VA Hot Springs DOM Renovation Building 8  
Hot Springs, South Dakota

**ADDENDUM NO.:** 01**DATE ISSUED:** 08-22-2025**BIDS DUE:** 09-03-2025**ARCHITECT'S PROJECT NO:** 211921

**Date:** 8/22/2025**Project:** Dom Renovation for Semiprivate Rooms**To:** All Plan Holders**Project #:** VA# 568-20-208, WPE# BR21039**From:** David Dowling/Michael Heinrich, Mike Sigman**Project Location:** Hot Springs, South Dakota**Addendum Number:** #001

**Drawing Number**  
EP-203-R1

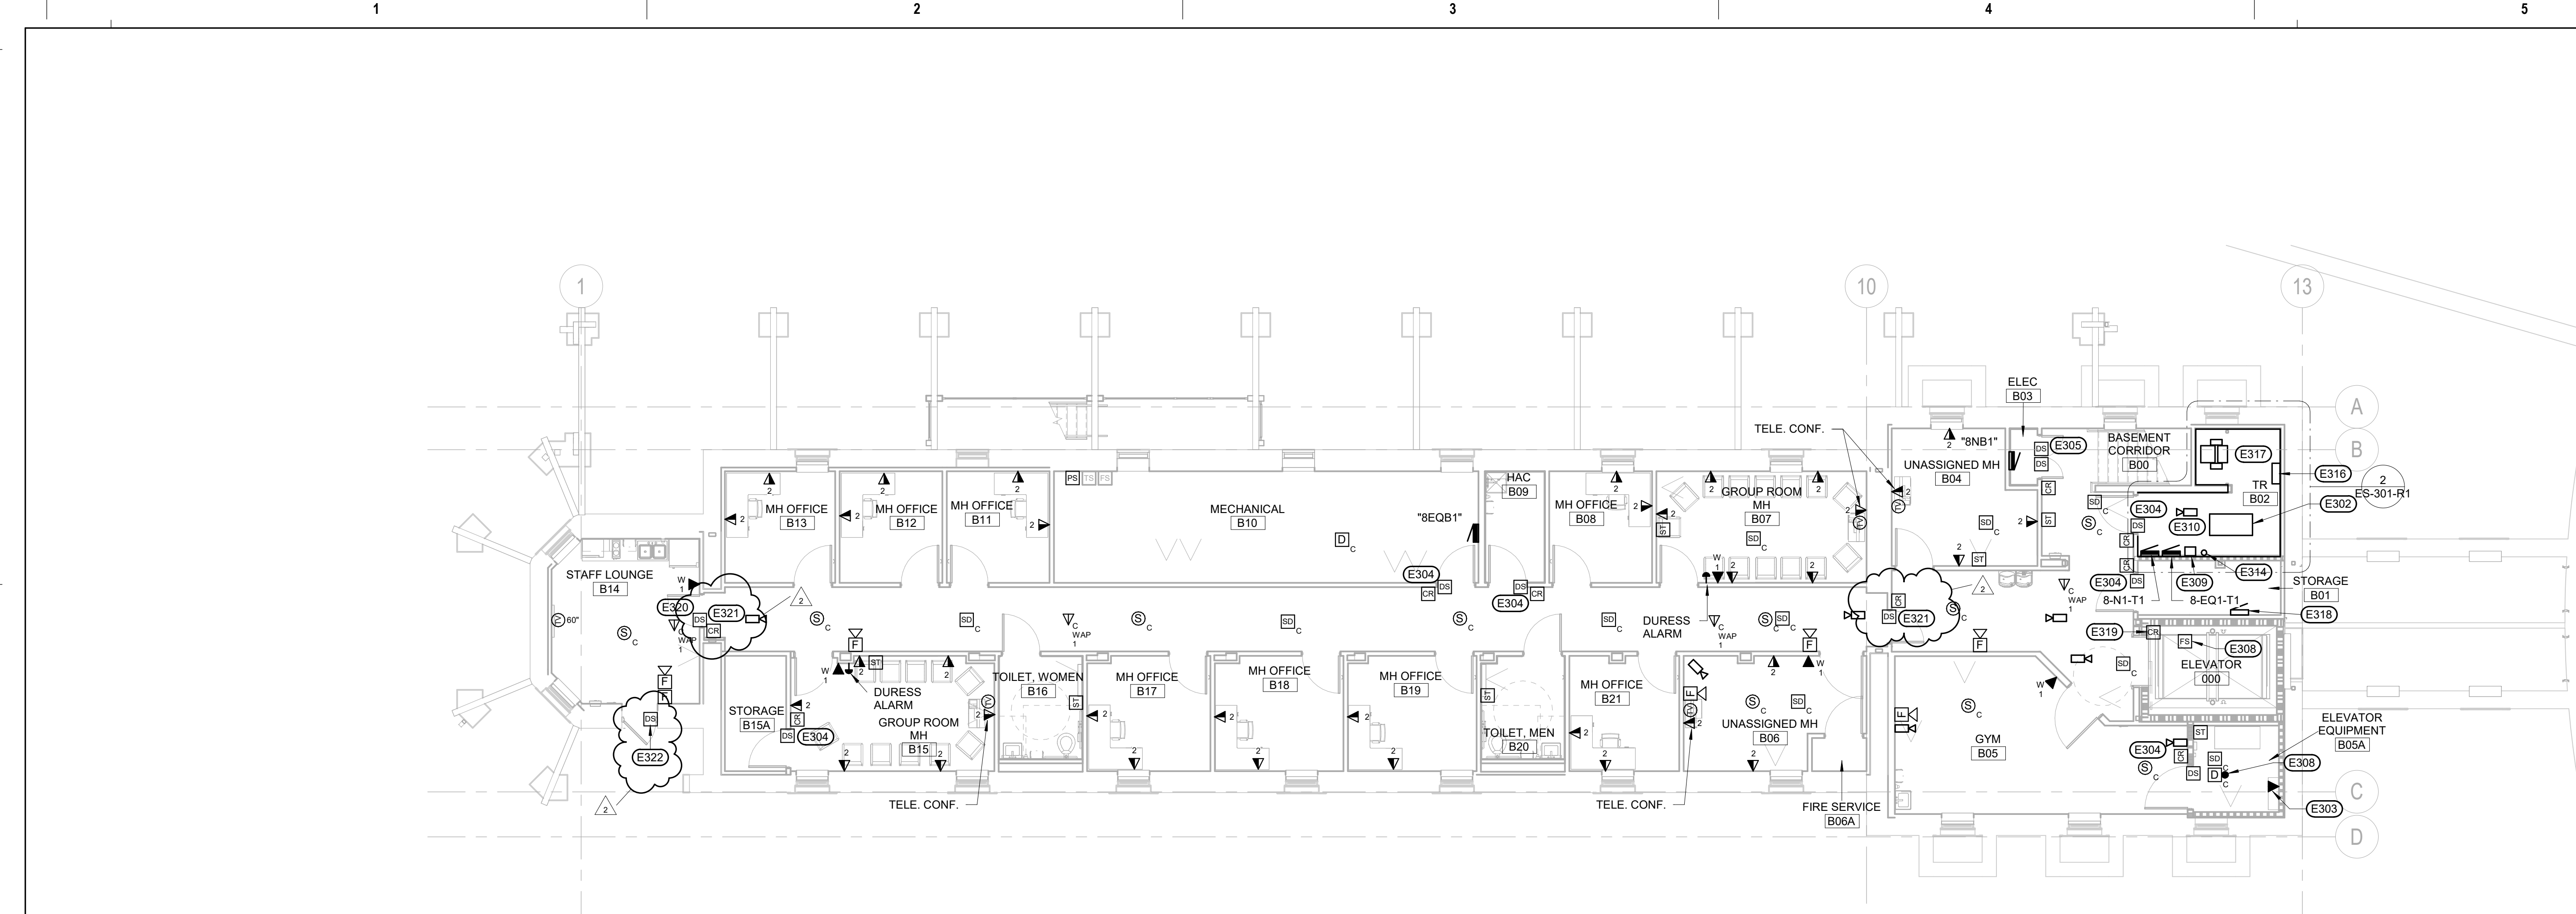
1. Modified specific note E213 as shown on the attached revised sheet EP-203-R1.
2. Added specific note E216 at door X2B as shown on the attached revised sheet EP-203-R1.
3. Removed ADA Operator from door X2B as shown on the attached revised sheet EP-203-R1.

1 SECOND FLOOR SIGNAL PLAN  
1/8" = 1'-0"

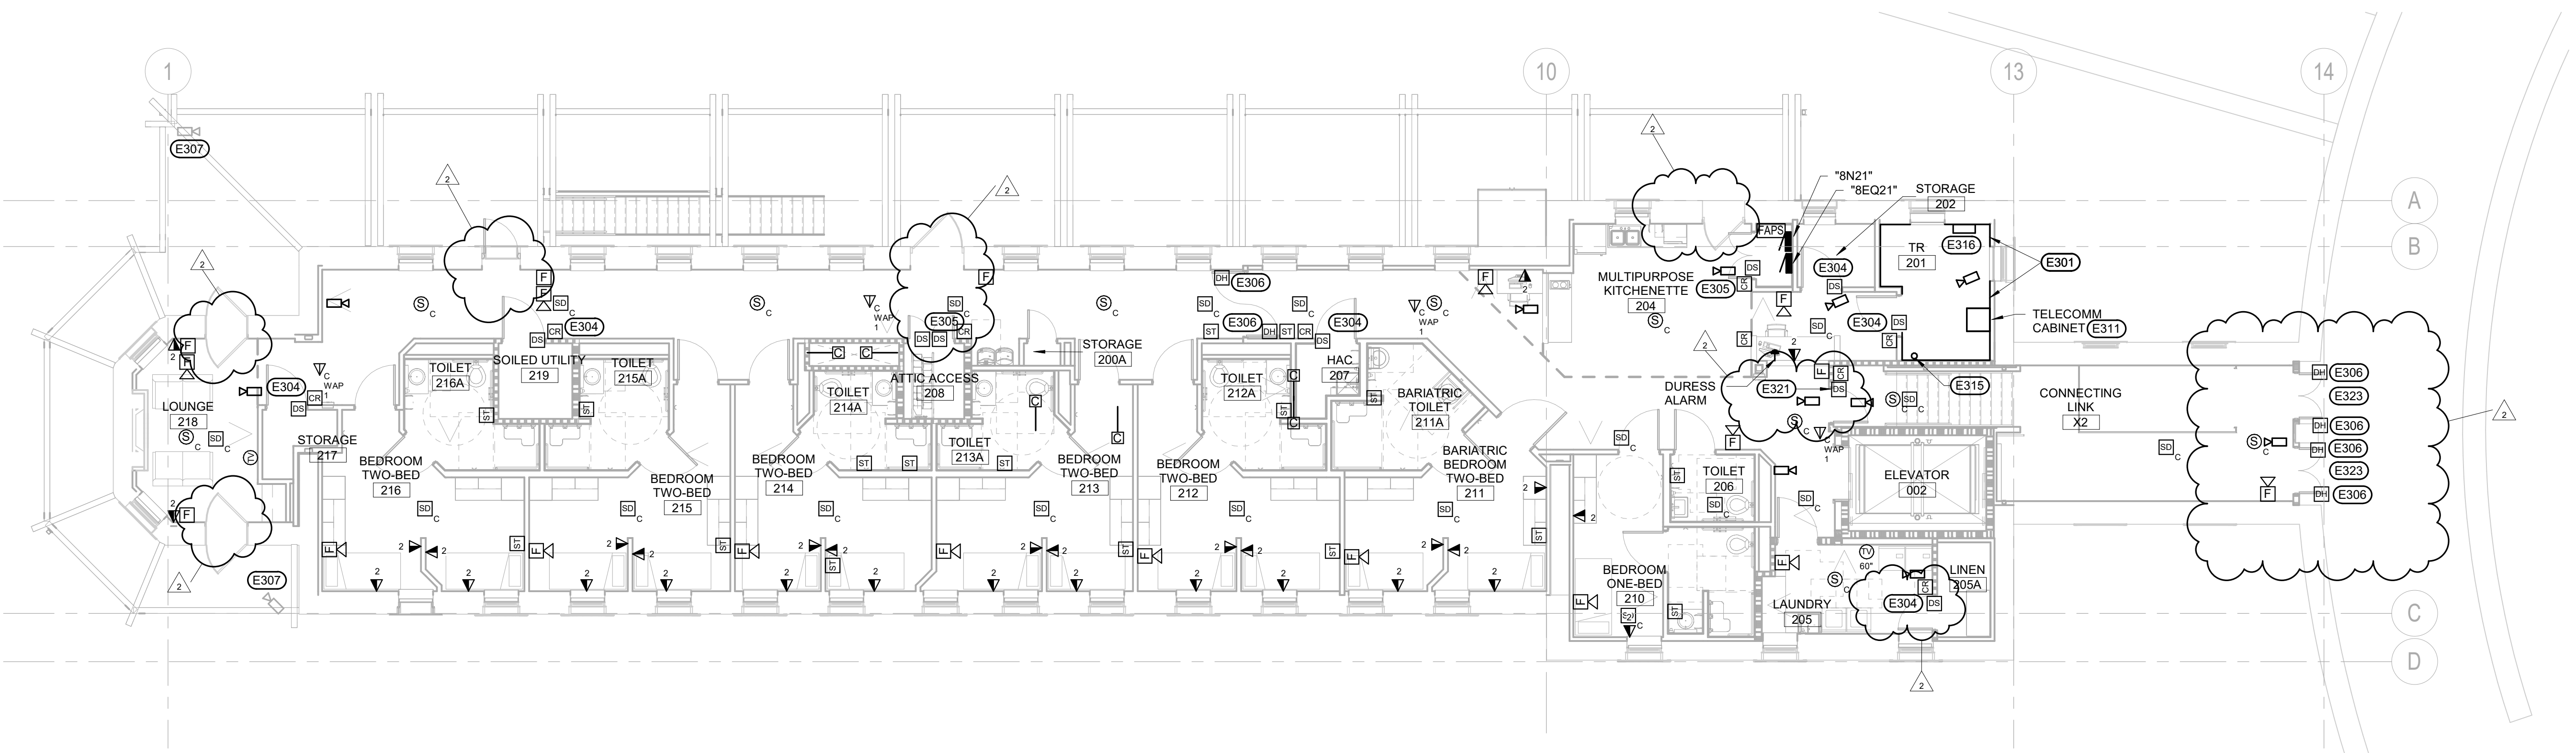
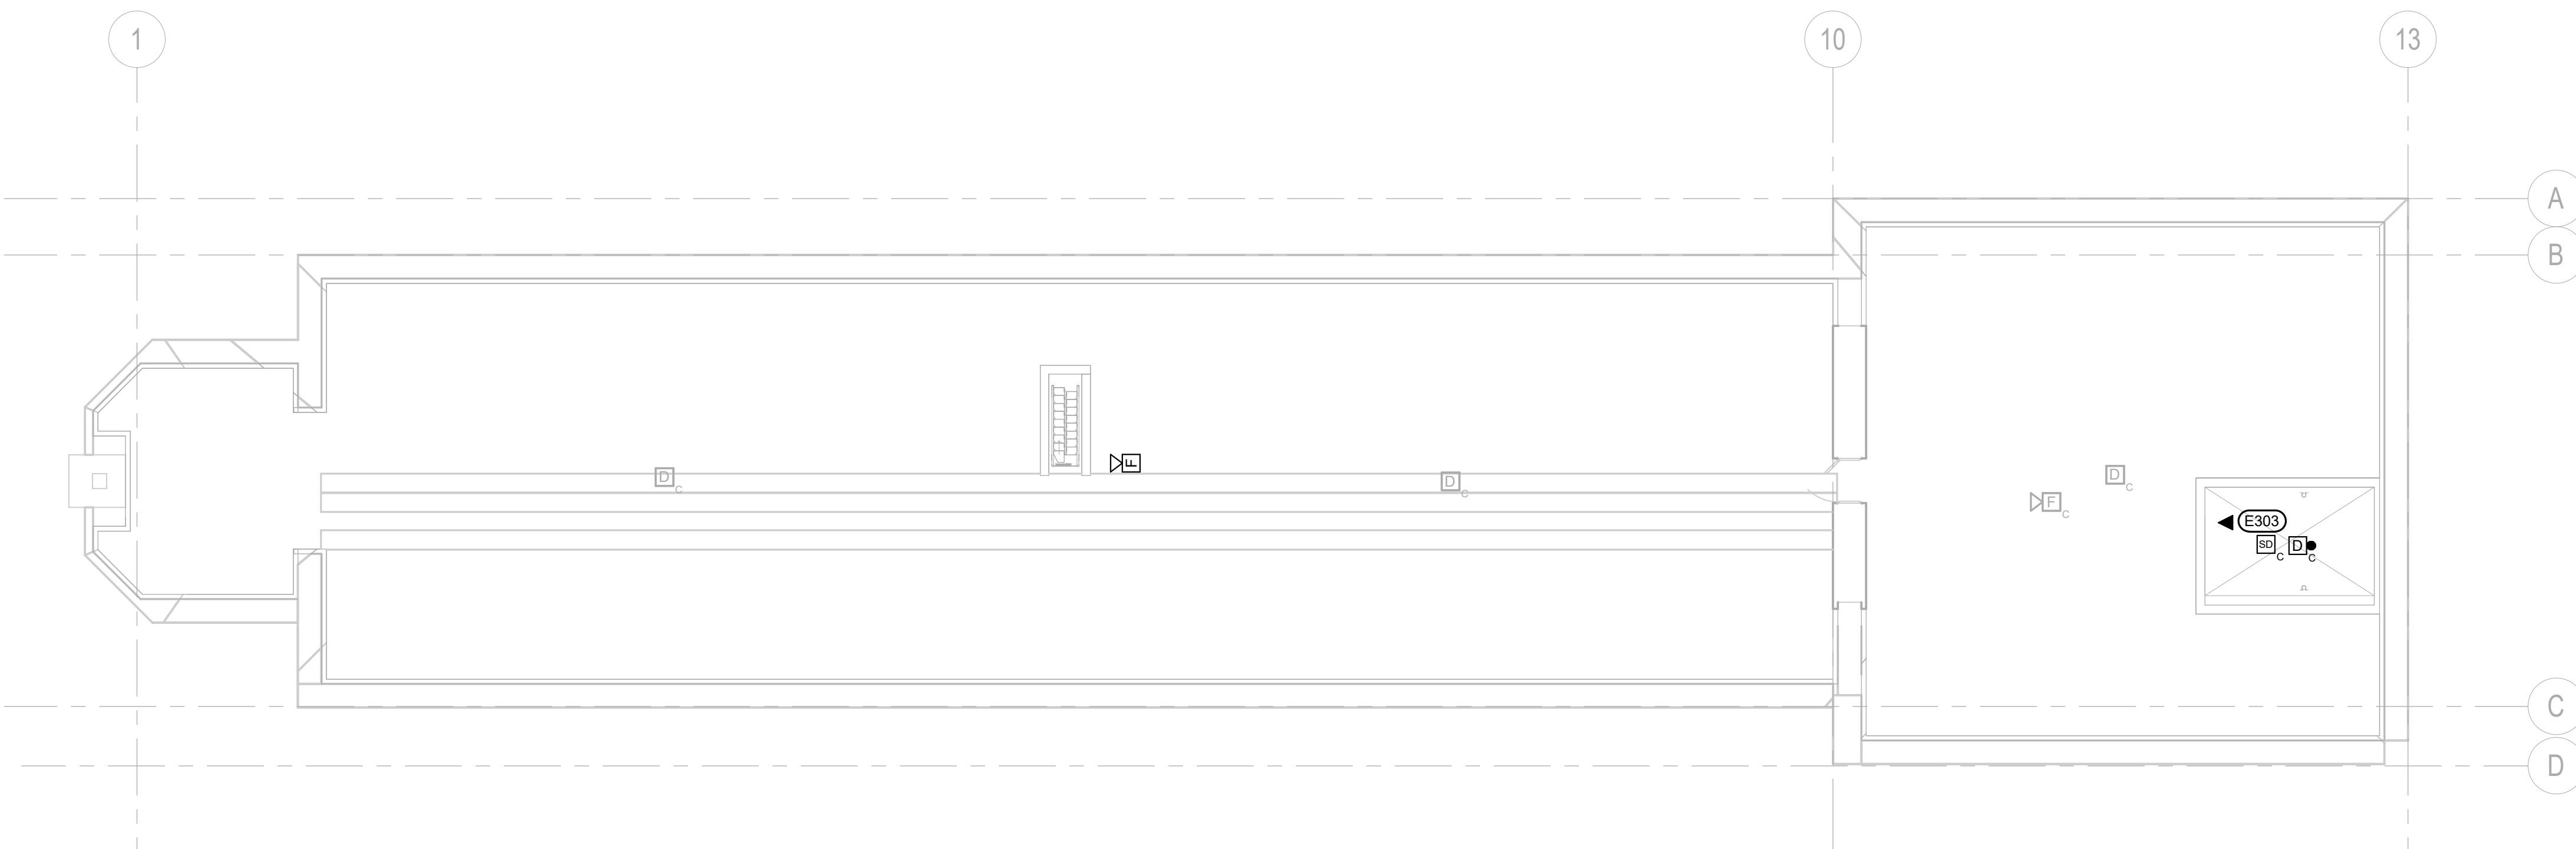
1. Modified specific notes E304, E305, E311 and E320 as shown on the attached revised sheet ES-303-R1.
2. Modified the note used at door 200 as shown on the attached revised sheet ES-303-R1.
3. Added new note E323 to doors X2A and X2B as shown on the attached revised sheet ES-303-R1.
4. Added note E304 to door 205A as shown on the attached revised sheet ES-303-R1.
5. Deleted access control from exterior doors at Lounge 218 and at doors leading exterior to the porch as shown on the attached revised sheet ES-303-R1.
